TRI-PARTY AGREEMENT

| Change Notice Number TPA-CN- 0738 | TPA CHANGE NOTICE FORM | Date: 8/5/2016 |
| Document Number, Title, and Revision: Removal Action Work Plan for River Corridor General Decommissioning Activities, April 2013, DOE/RL-2010-34, Rev. 2 | | Date Document Last Issued: 4/8/2015 |

Description of Change:
 Adds 10 buildings associated with the Research Technology Laboratory to the General Decommissioning RAWP.

Figure 1-1. Hanford Site Map.

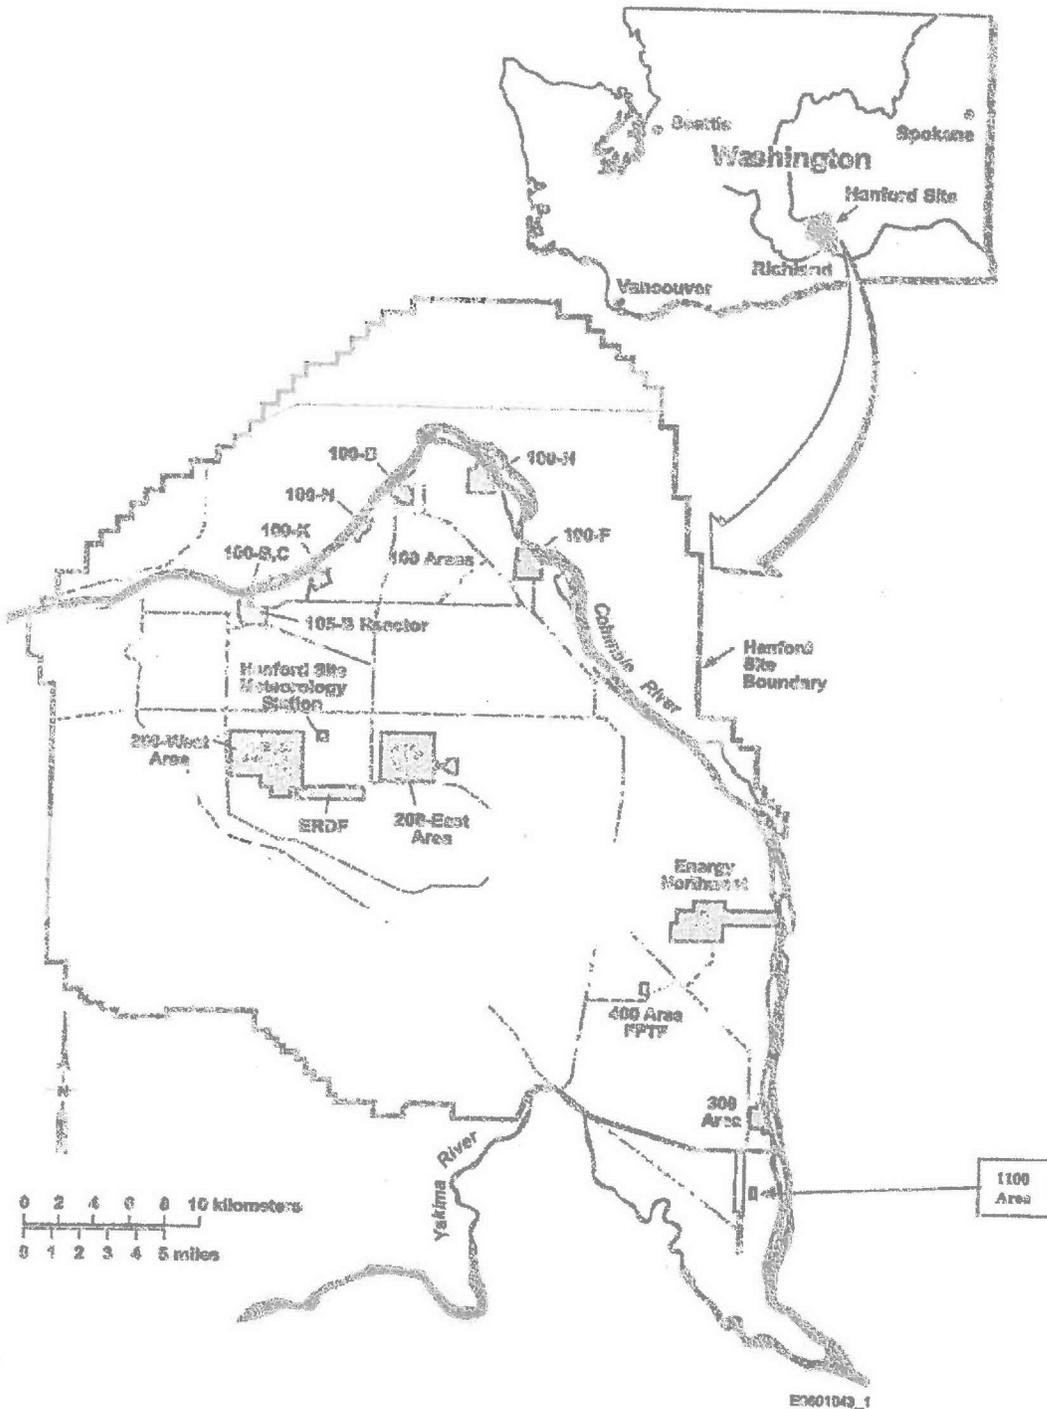
Add a new Figure 1-1 to show location of the 1100 Area

These areas include the 100 Areas, 300 Area, 400 Area, 600 Area and 1100 Area (Figure 1-1).
